CABINET MEMBER FOR ENVIRONMENT - 21 JULY 2016

**PROPOSED PARKING RESTRICTIONS, 20MPH SPEED LIMIT &
LOADING RESTRICTIONS
GREAT WESTERN PARK, DIDCOT**

Report by Deputy Director of Environment & Economy (Commercial)

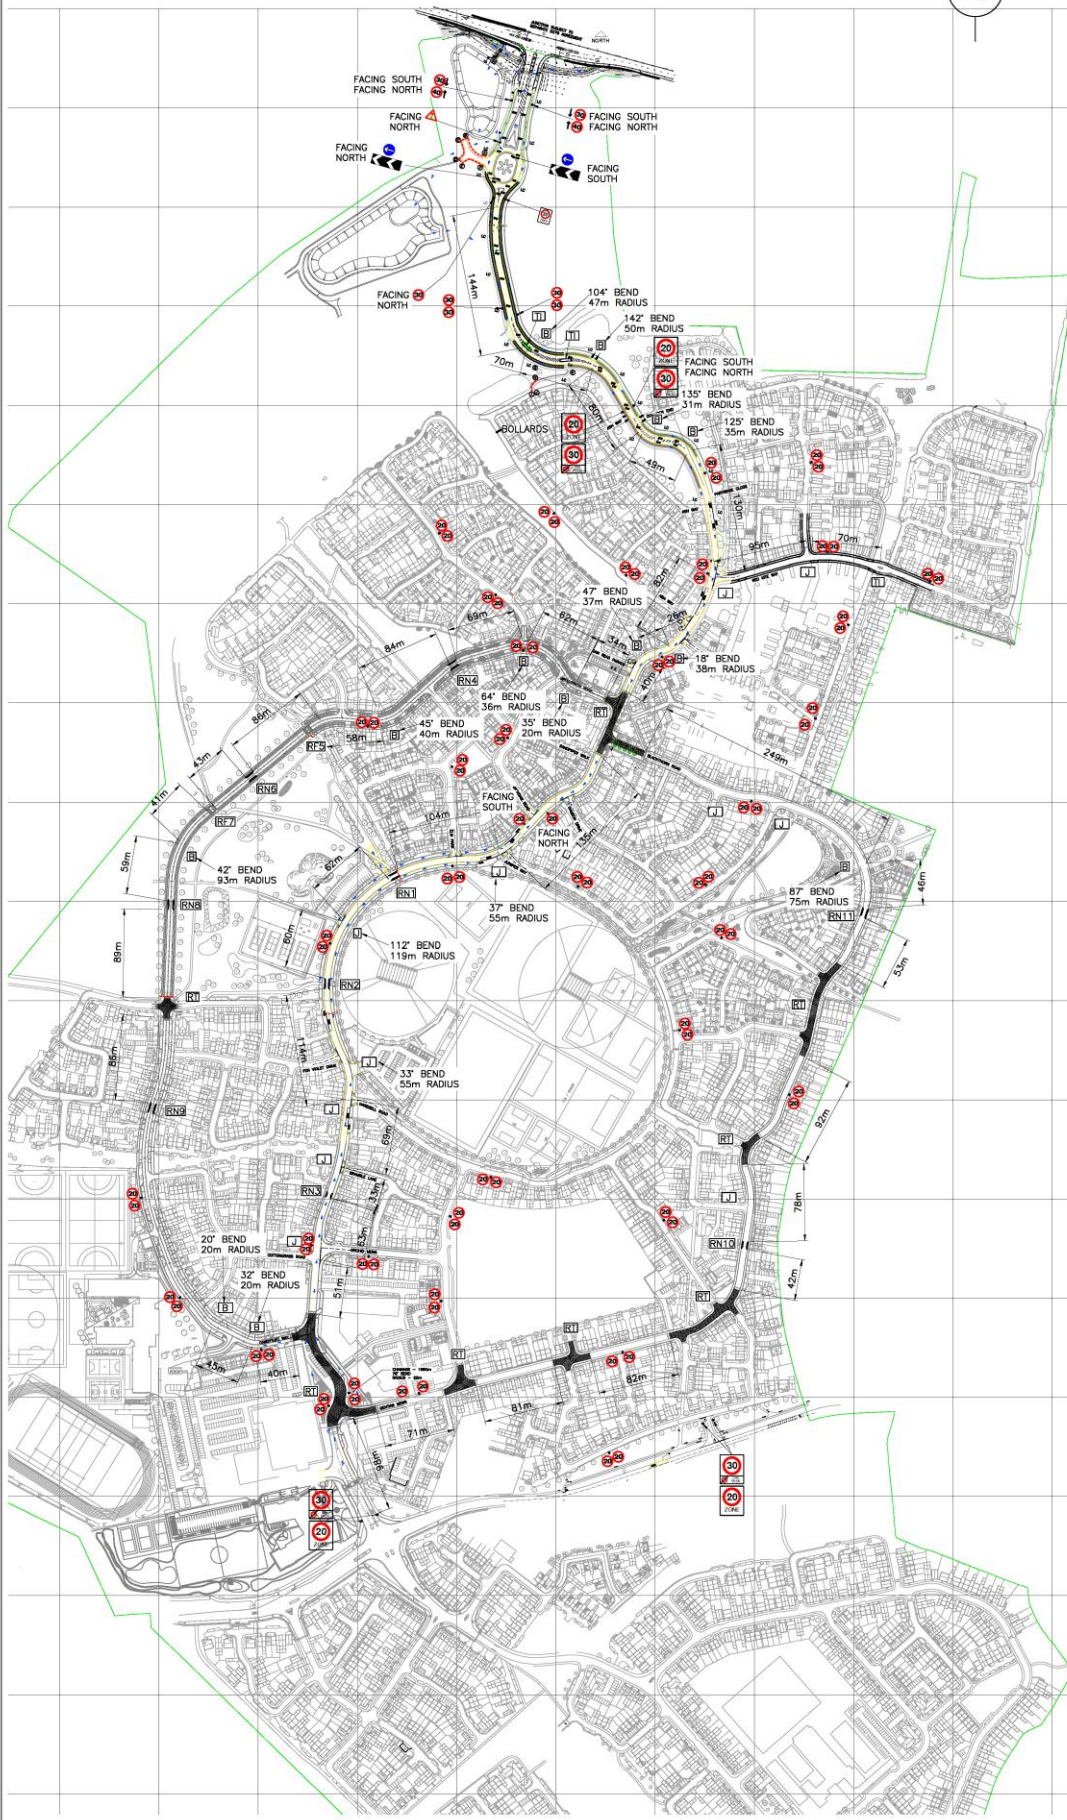
RESPONDENT	SUMMARISED COMMENTS
(1) Thames Valley Police	<p>No objection to speed limit – but has the following comments:</p> <ul style="list-style-type: none"> ▪ TVP policy is that 20mph speed limits should be self-enforcing, ▪ Further engineering measures should be considered in the future if residential complaints regarding speeding increase – in order to restrict burden on Police. <p>No objection to parking restrictions – but has the following comments:</p> <ul style="list-style-type: none"> ▪ Feels parked vehicles can act as a deterrent and control to speeding vehicles (i.e. artificial calming), ▪ Future Police enforcement is determined by a number of factors, and TVP's operational priorities mean that issues affecting public safety and those that have an impact on traffic flow on main routes will always be given priority. <p>Objects to the loading bay restriction – due to the following reasons:</p> <ul style="list-style-type: none"> ▪ Places a considerable burden upon Officers who have to observe/monitor vehicles throughout this time period in order for an offence to be 'complete', ▪ Would strongly recommend that waiting is restricted to 30 minutes or less, in line with the majority of other such restrictions, ▪ This form of restriction will feature extremely low in terms of TVP enforcement priorities,

(2) Local County Councillor (Didcot West)	<p>Supports all the proposals – with the following comments:</p> <ul style="list-style-type: none"> ▪ Feels that the 20mph speed restriction is an essential component, ▪ Particularly supports the parking restrictions on the spine road,

(3) Didcot Town Council	<p>Supports – with the following comments:</p> <ul style="list-style-type: none"> ▪ Welcomes the proposed 20mph speed limit, ▪ Welcomes the propose loading bay restrictions, as it is viewed as a ‘good step’ forward in providing the necessary servicing for local business’.

(7) Online Response, (unknown)	<p>Supports the speed limit – with the following comments:</p> <ul style="list-style-type: none"> ▪ Feels that the current speed limit is unsafe and that restricting the speeds is sensible, making the neighbourhood ‘less hostile’ for pedestrians. <p>Supports the parking restrictions.</p>

(8) Resident, (Barrow Lane)	<p>Supports the speed limit – with the following comments:</p> <ul style="list-style-type: none"> ▪ Strongly supports the use of 20mph speed limits in residential areas, ▪ Would like to see their use increased in the surrounding areas, such as Harwell. <p>Supports the parking restrictions.</p>

(9) Resident, (unknown)	<p>No objection to the parking restrictions – with the following comments:</p> <ul style="list-style-type: none"> ▪ Concerned that the residents will be unhappy with the proposed restrictions in the side roads. <p>No objection to the speed limit – with the following comments:</p> <ul style="list-style-type: none"> ▪ Questions how the speed limit will be enforced, feels that signs won’t be enough.

19. **The Cabinet Member for the Environment is RECOMMENDED to:-**
 - (a) **approve implementation of no waiting at any time parking restrictions and 20mph speed limit zone proposals as advertised;**
